LOT 6 - PARKER AND PINE FILING 1.
SITUATED IN THE SE 1/4 OF SECTION 9 AND THE SW 1/4
OF SECTION 10, T.6S., R.66W. OF THE 6TH P.M.
TOWN OF PARKER, COUNTY OF DOUGLAS,
STATE OF COLORADO

Sheet Number	Sheet Title
C7.0	COVER SHEET
C7.1	WATER AND SANITATION NOTES
C7.2	UTILITY PLAN
C7.3	SANITARY SEWER LINE PLAN AND PROFILE
C7.4	WATER LINE PLAN AND PROFILE
C7.5	WATER & SANITARY SEWER DETAILS

LOT 6 PARKER AND PINE FILING 1
PARKER, CO
EVERBROOK ACADEMY CONSTRUCTION DOCUMENTS
COVER SHEET

C7.3

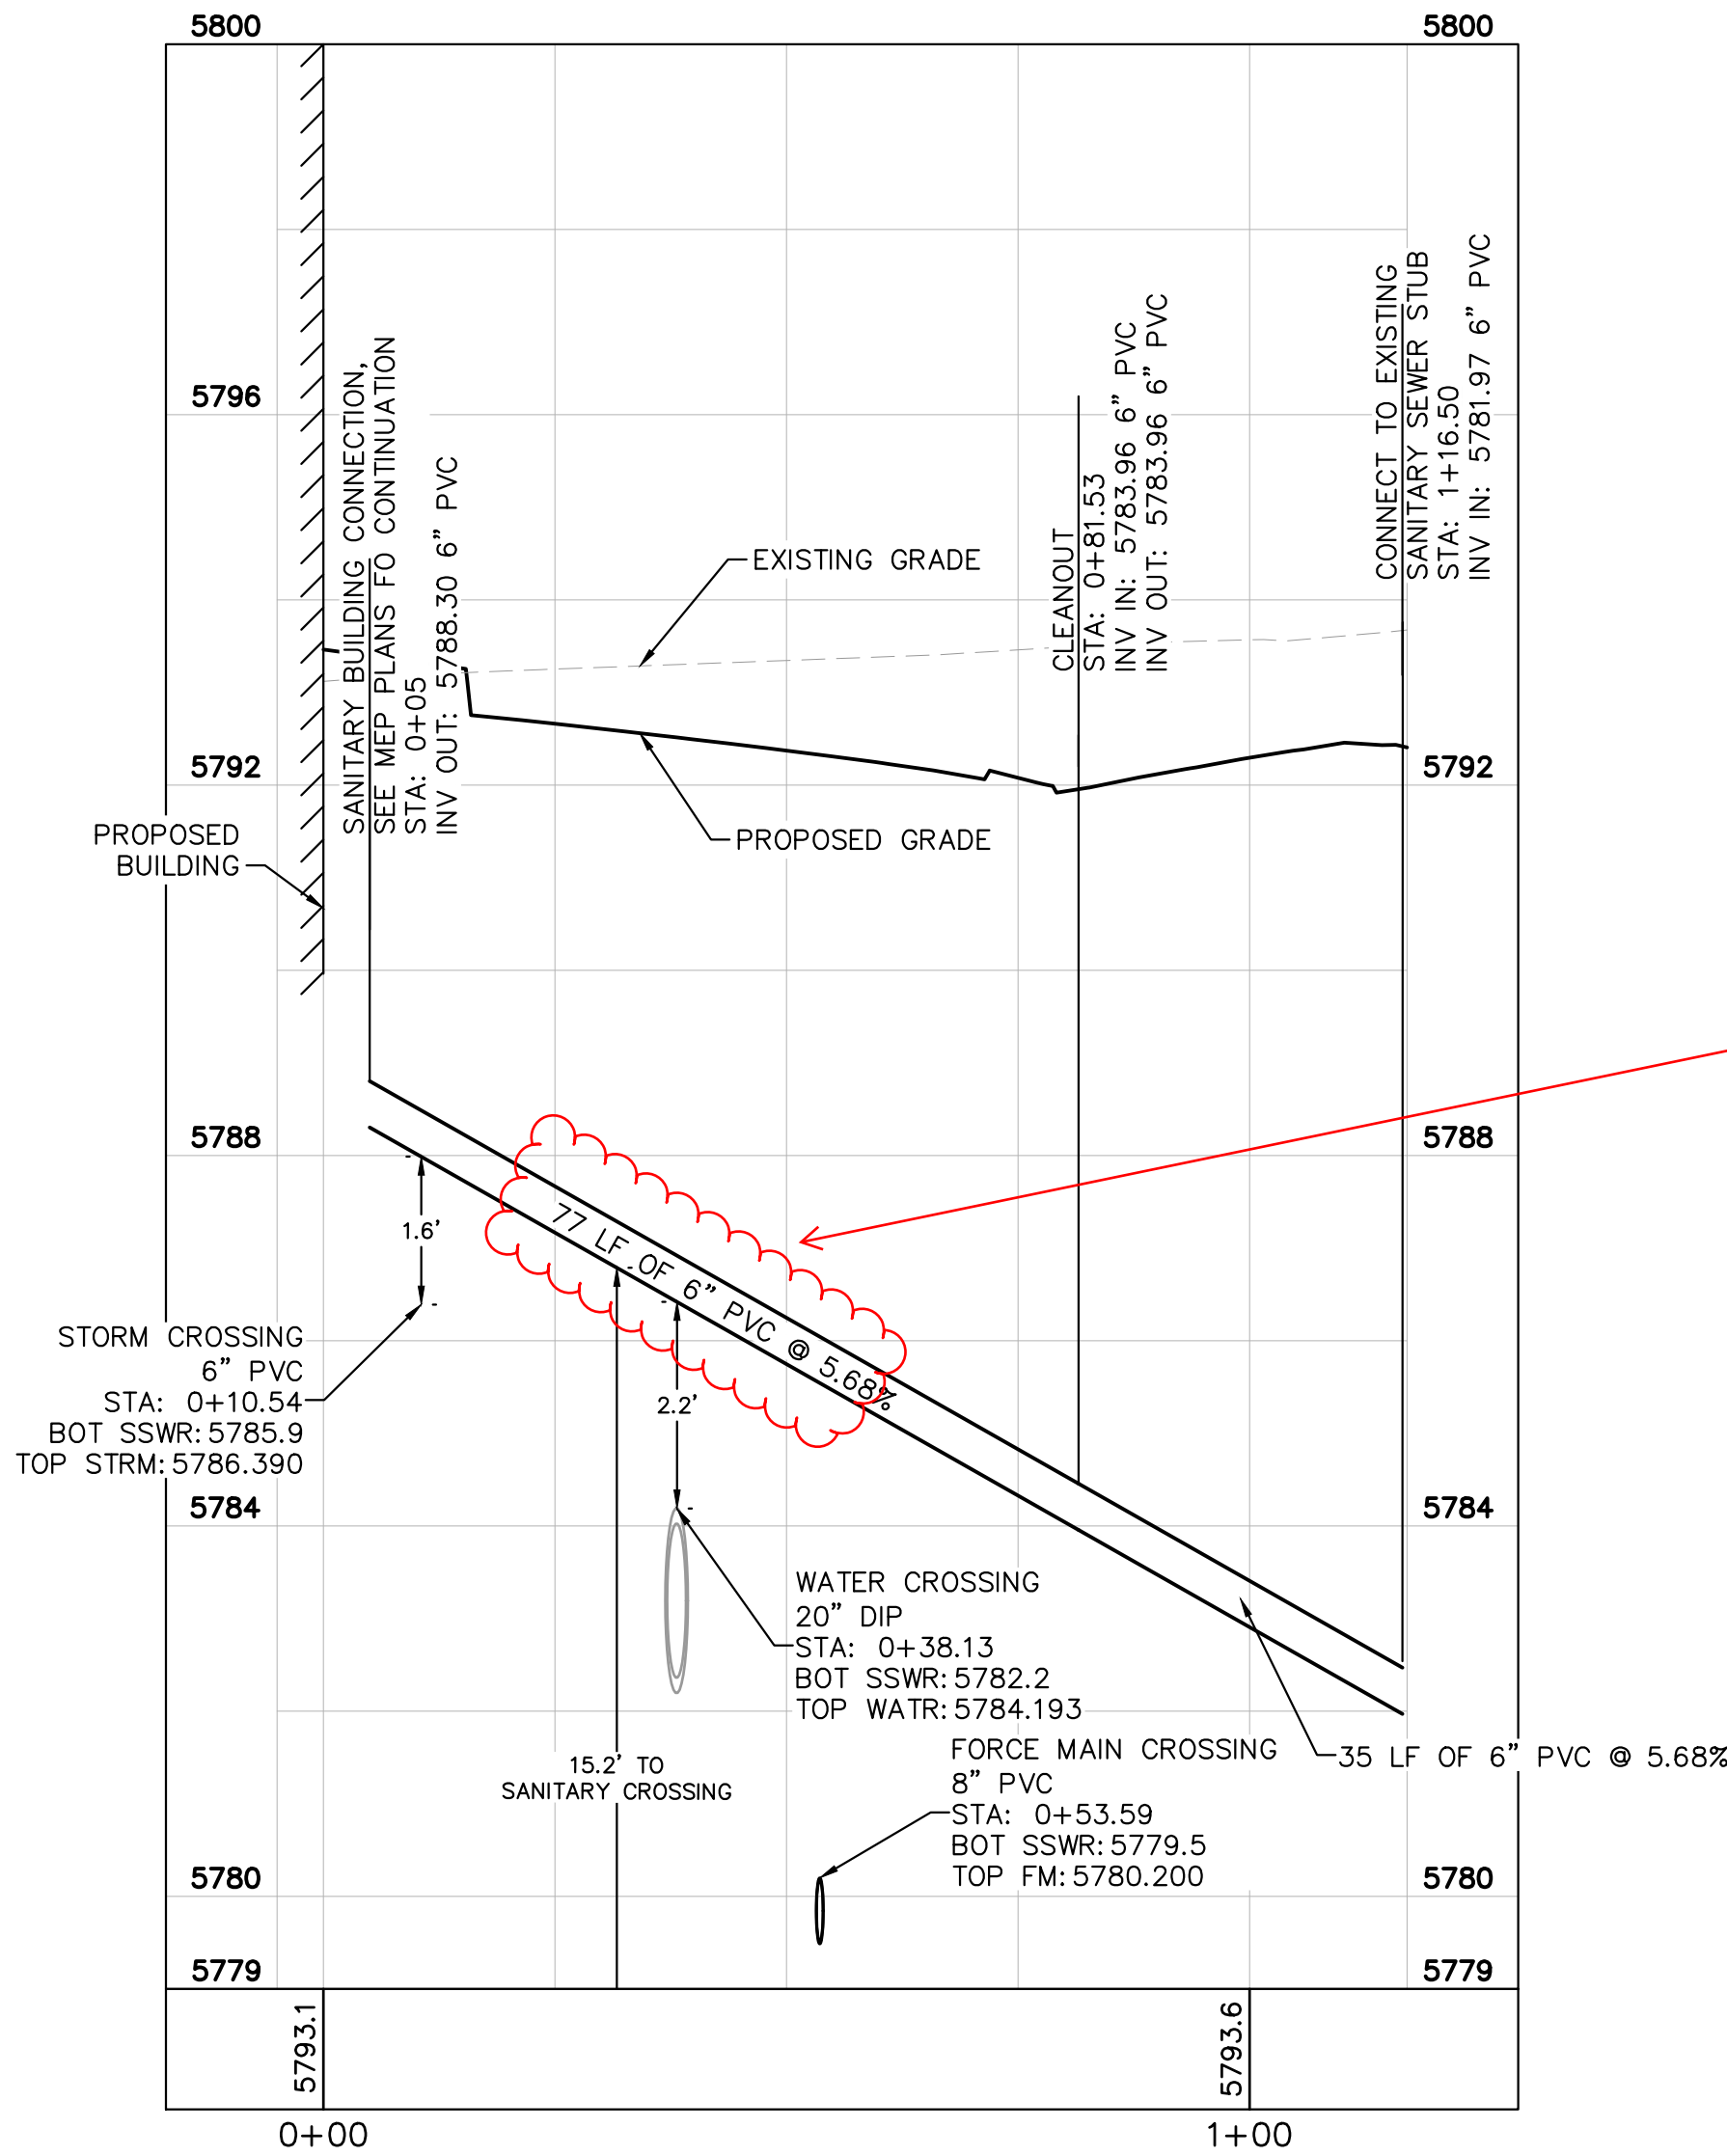
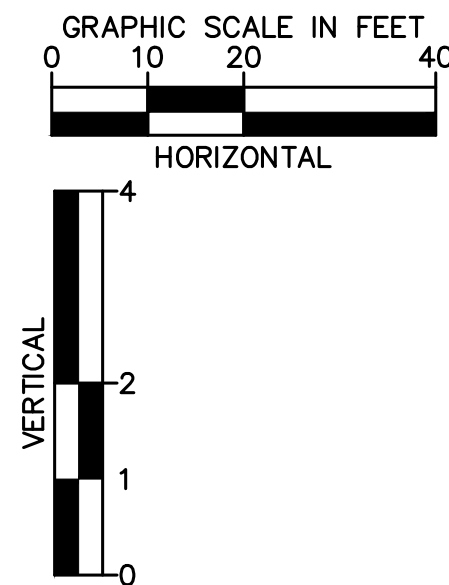
Encase 10ft to each side

Encasement added.
